### **HARRISON HILLS REPLAT 4**

**RECOMMENDATION REPORT**

CASE NUMBER: 2012-SUB-06

RE: Application for Replat-Initial Review  
Harrison Hills Replat 4(Replat of Harrison Hills Lot 12)

SARPY COUNTY,  
NEBRASKA  
PRELIMINARY PLAT

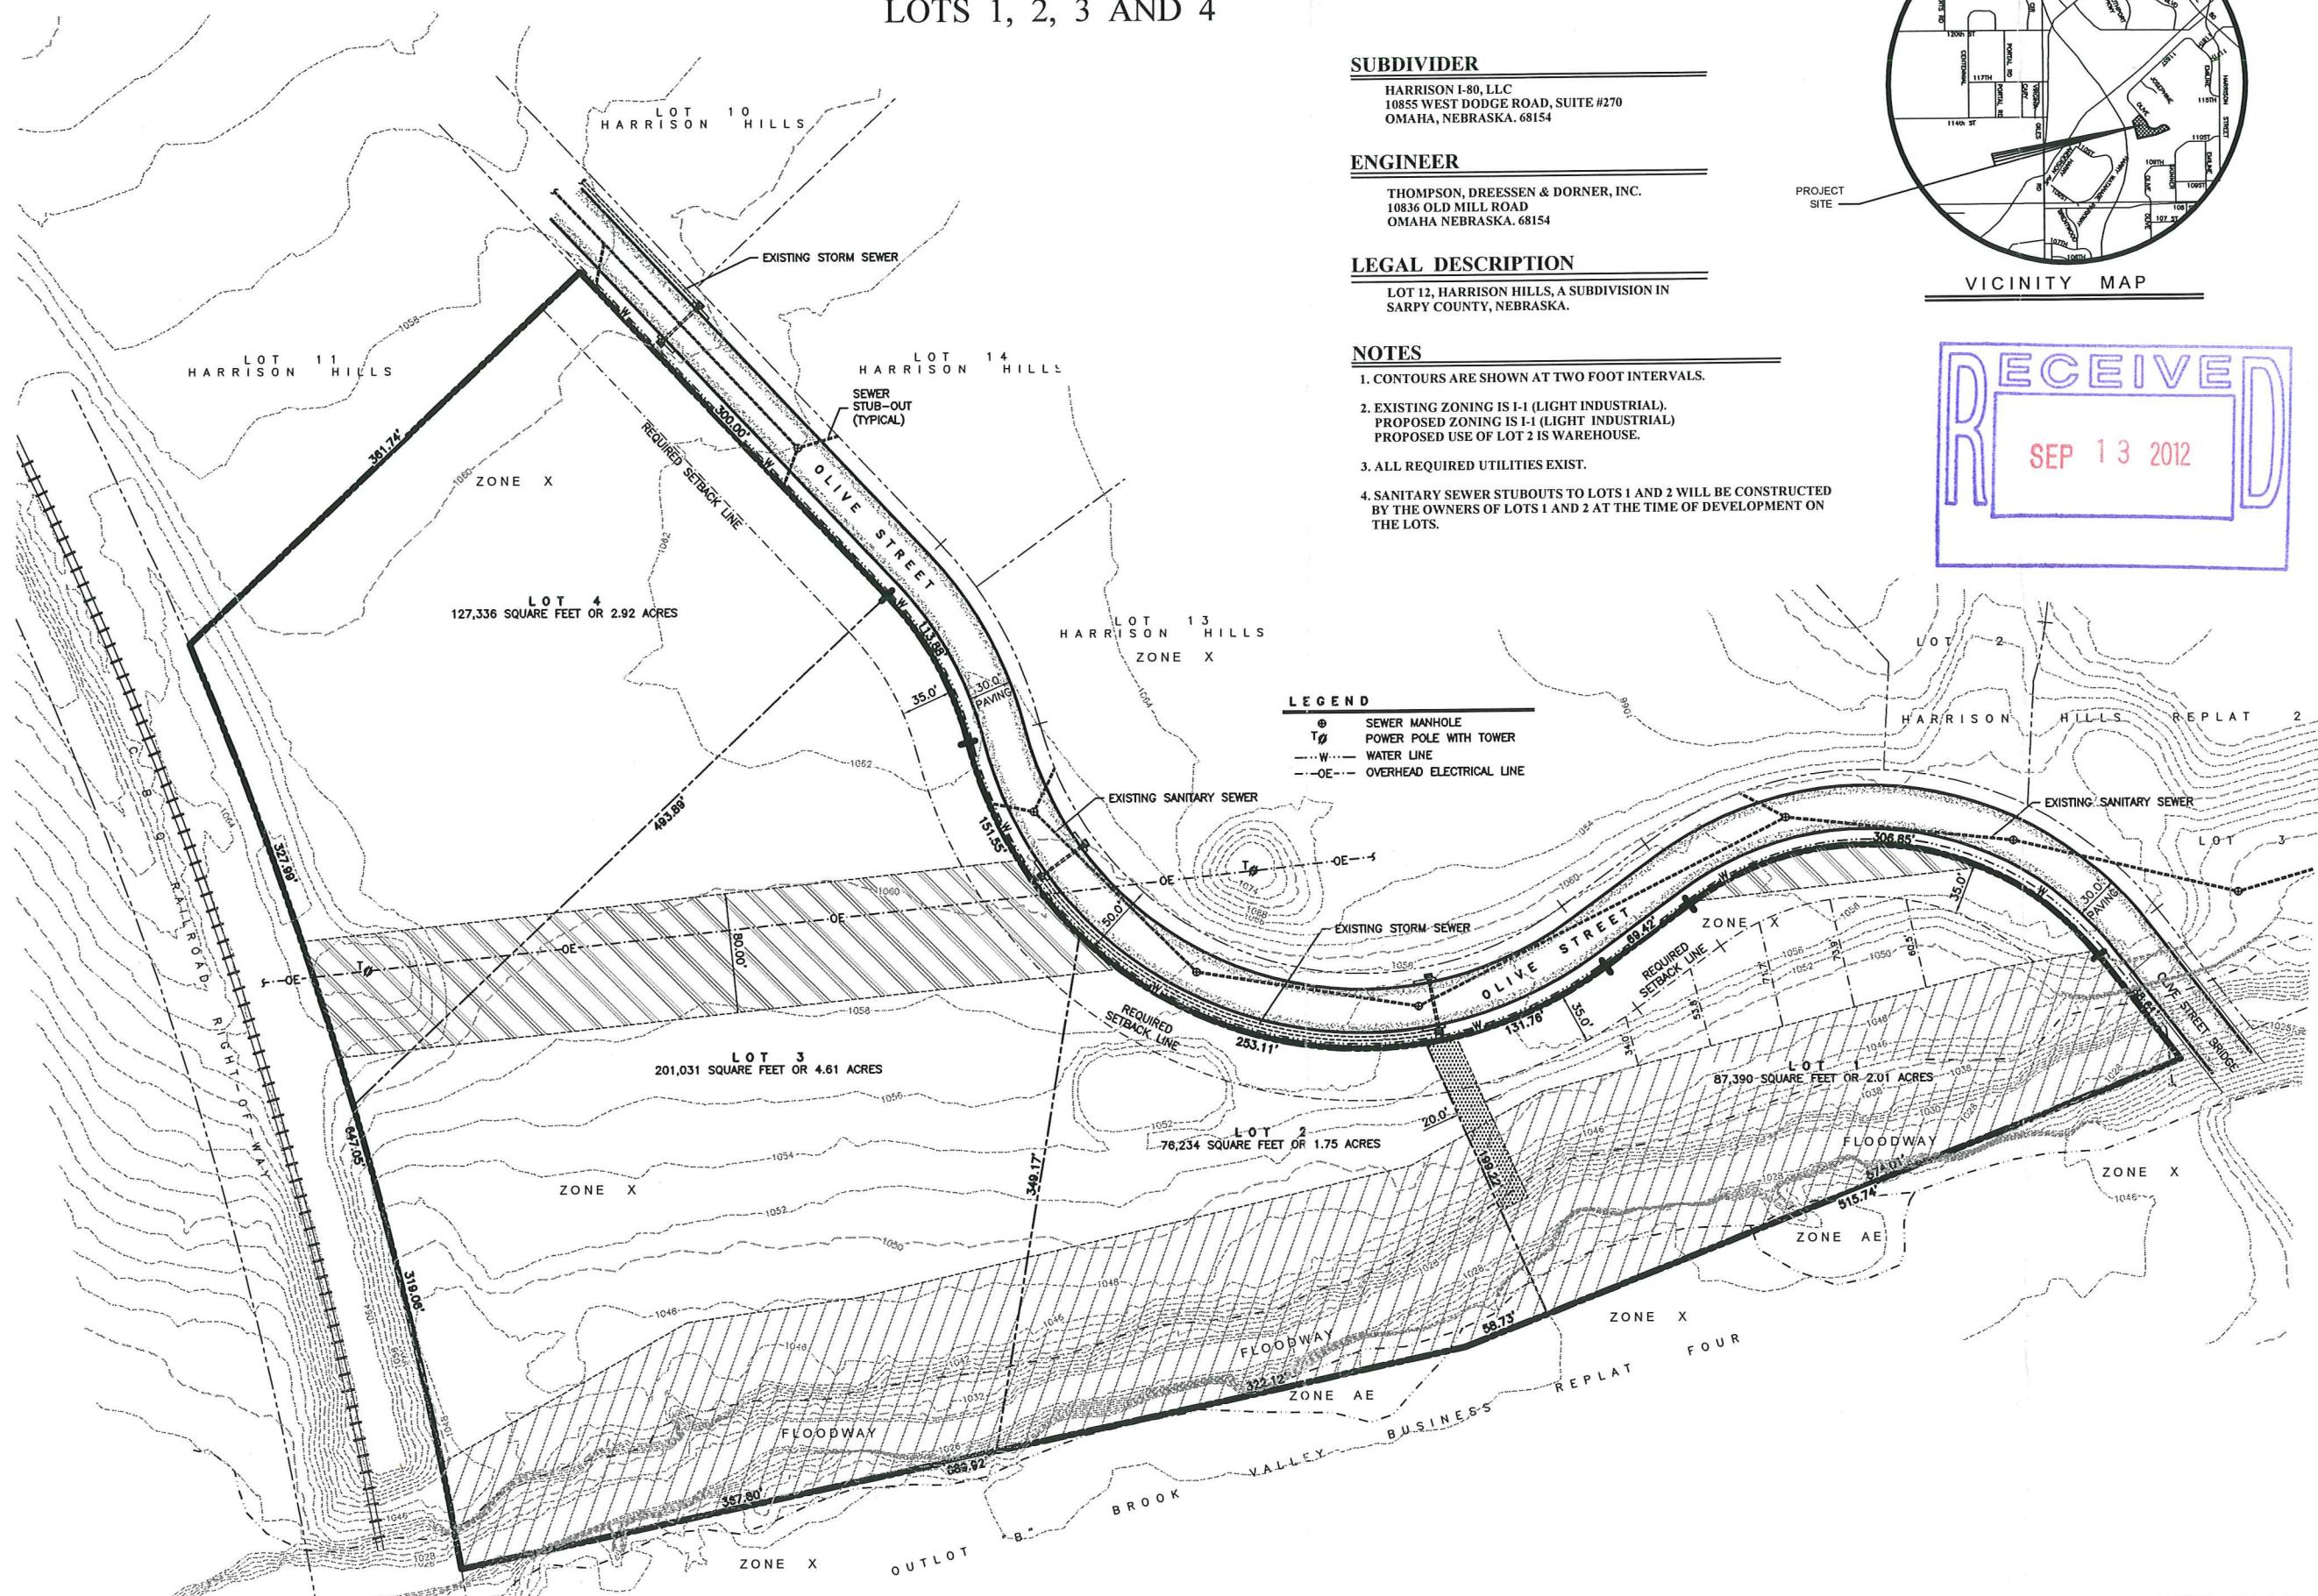
- B. The labeling of the existing contours needs to be checked as they appear to be about 20 feet too low in comparison the 100-year flood elevations listed on the FIRM maps in this location.
- C. The proposed signature block for the Register of Deeds needs to replaced with adequate space for a sticker to be applied by the Register of Deeds.

7. The preliminary plat was reviewed for compliance with Section 3.03 of the Subdivision Regulations. Comments from that review are as follows:
  - a. The existing contours need to be shown on the preliminary plat. These can be obtained from the Sarpy County GIS information or as-built records that the engineers for the applicant may have on file. This is needed in order to demonstrate the usable space and to identify the existing water course and/or ravines. Refer to Articles 3.03.03 and 3.03.07 of the Subdivision Regulations. Proposed contours will not be required since grading is not required to create the lots. Proposed contours will be required as part of building plans for each lot when built upon.
  - b. The location of the west end of the existing Olive Street bridge needs to be shown on the preliminary plat. See Article 3.03.07 of the Subdivision Regulations.

- c. Show the existing floodway and floodplain limits on the preliminary plat. See Article 3.03.13 of the Subdivision Regulations.

# HARRISON HILLS REPLAT 4

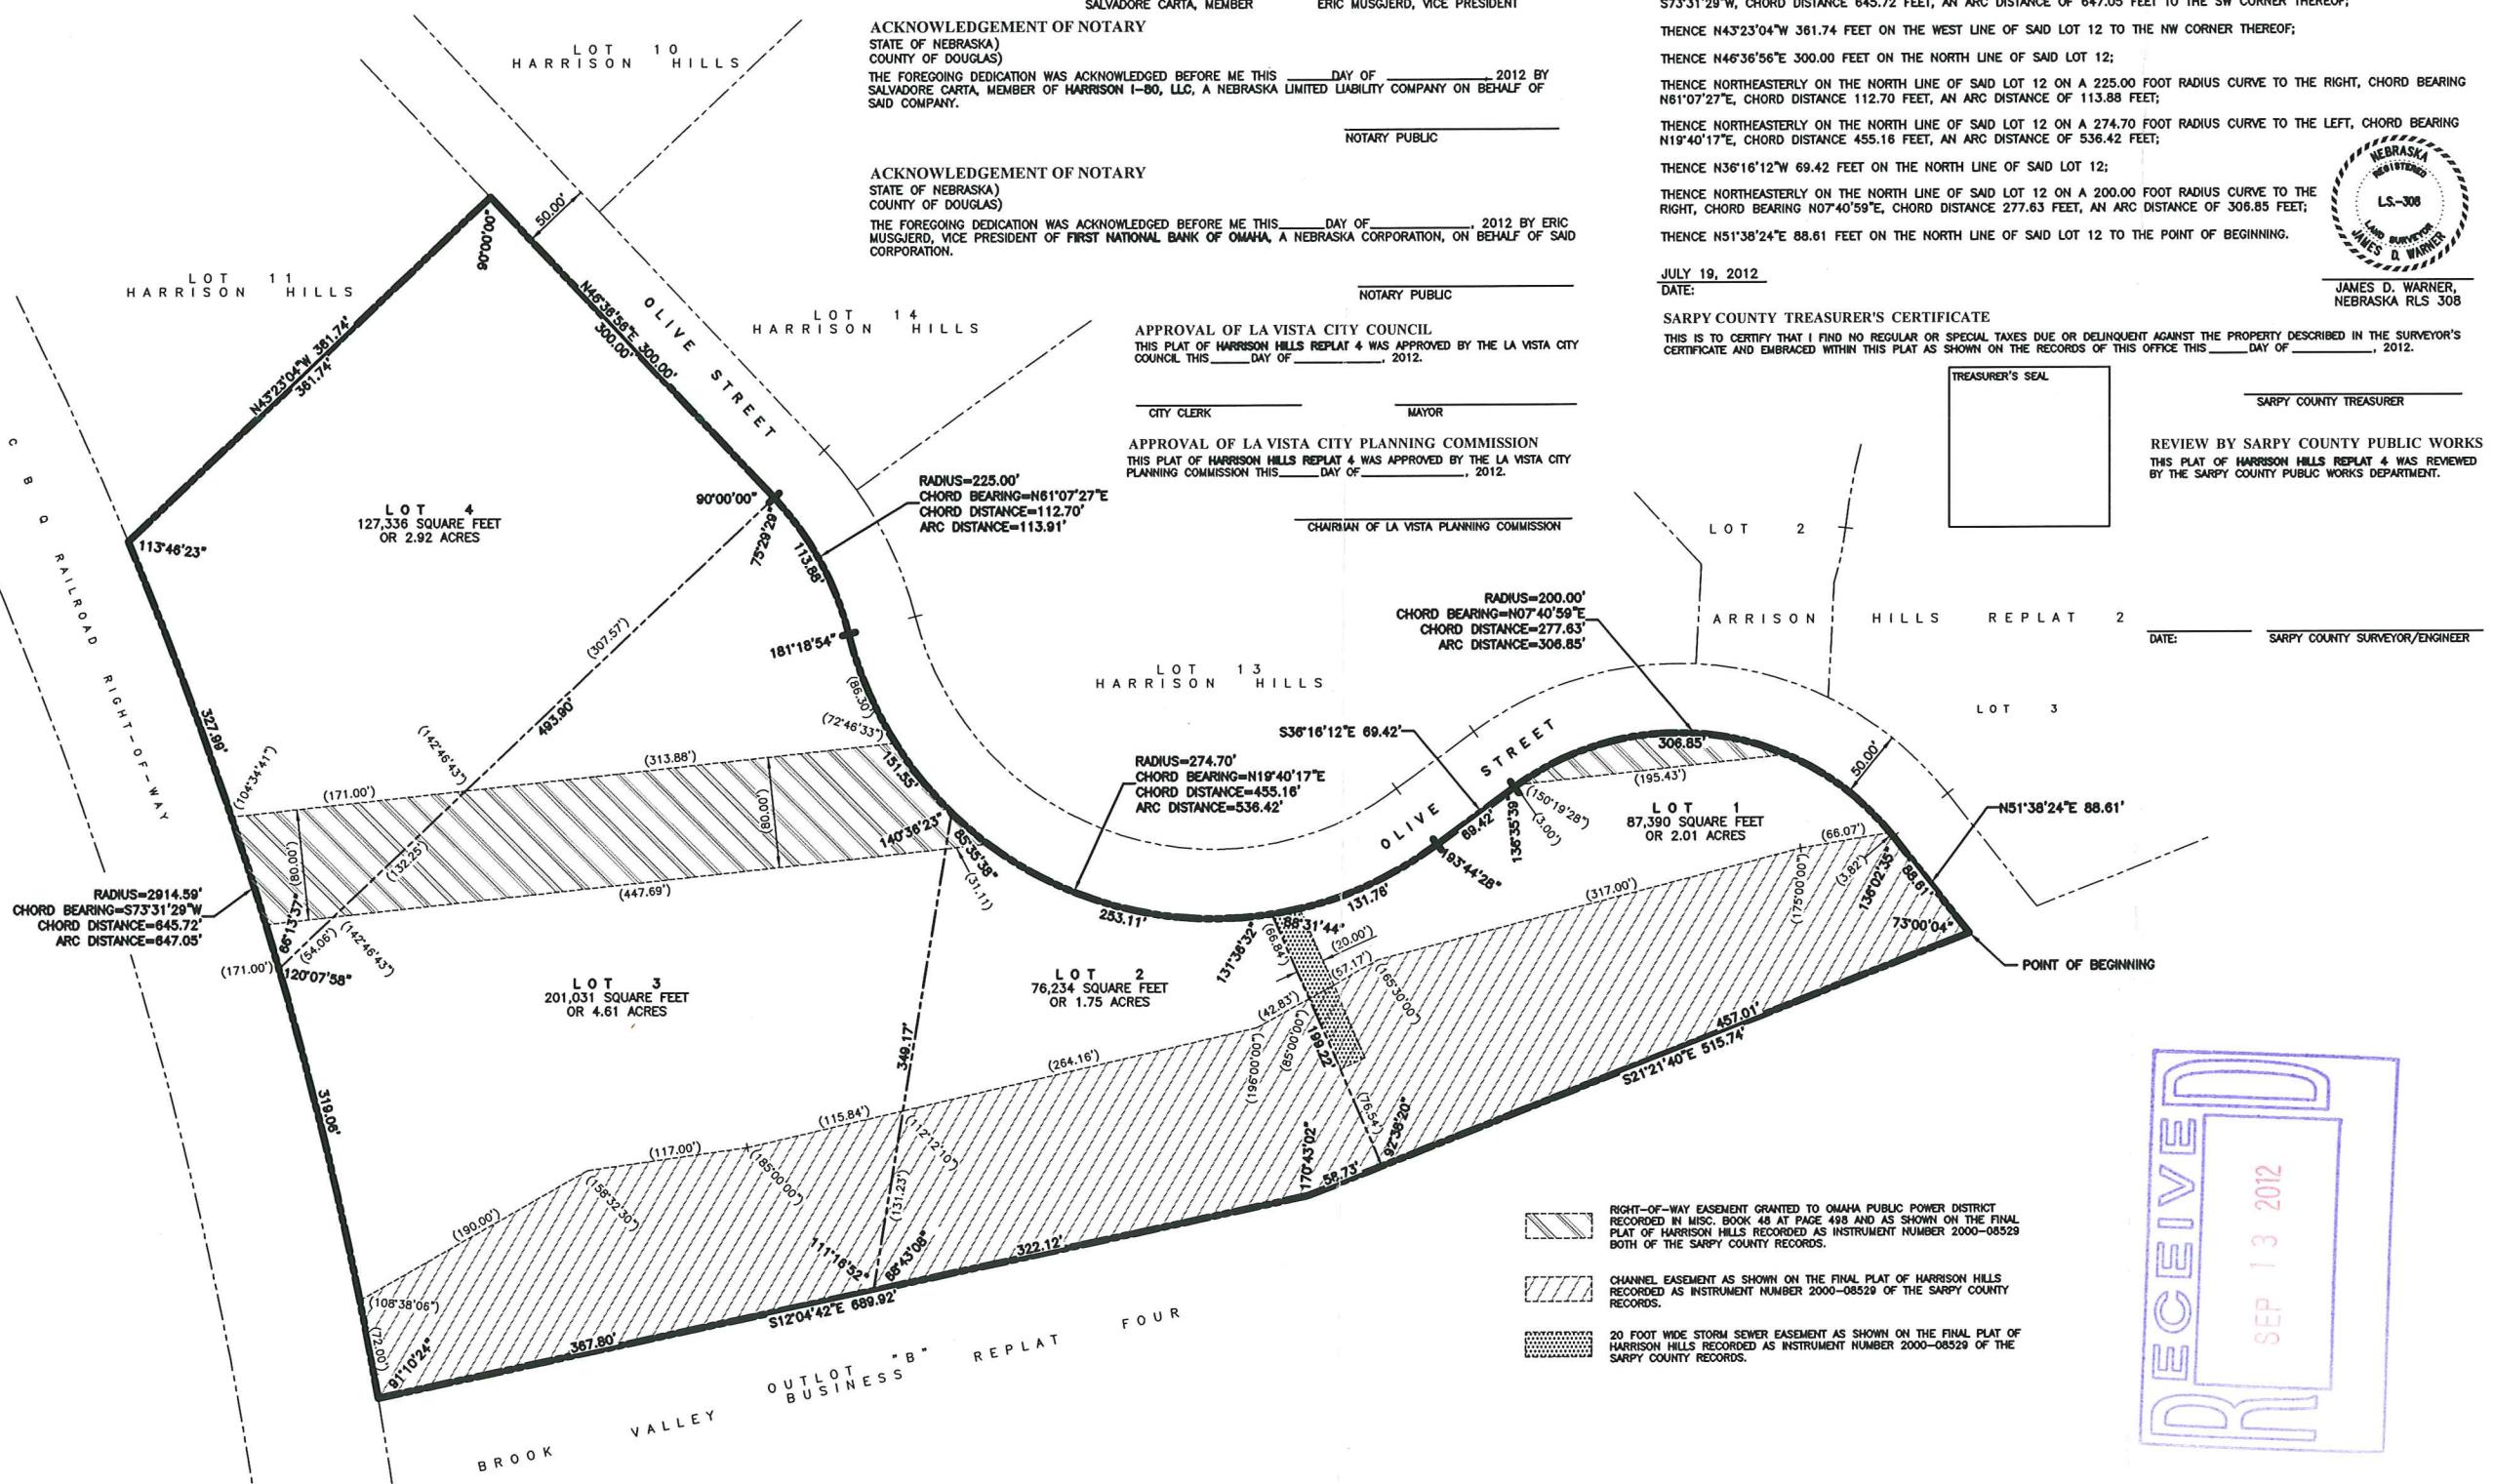
- a. The graphic scale on the final plat appears to be wrong. It is shown as 50 scale, but the drawing appears to be drawn at 60 scale.
- b. The approval block for the Planning Commission is missing and needs to be added.
- c. A signature block for the Register of Deeds needs to be provided.
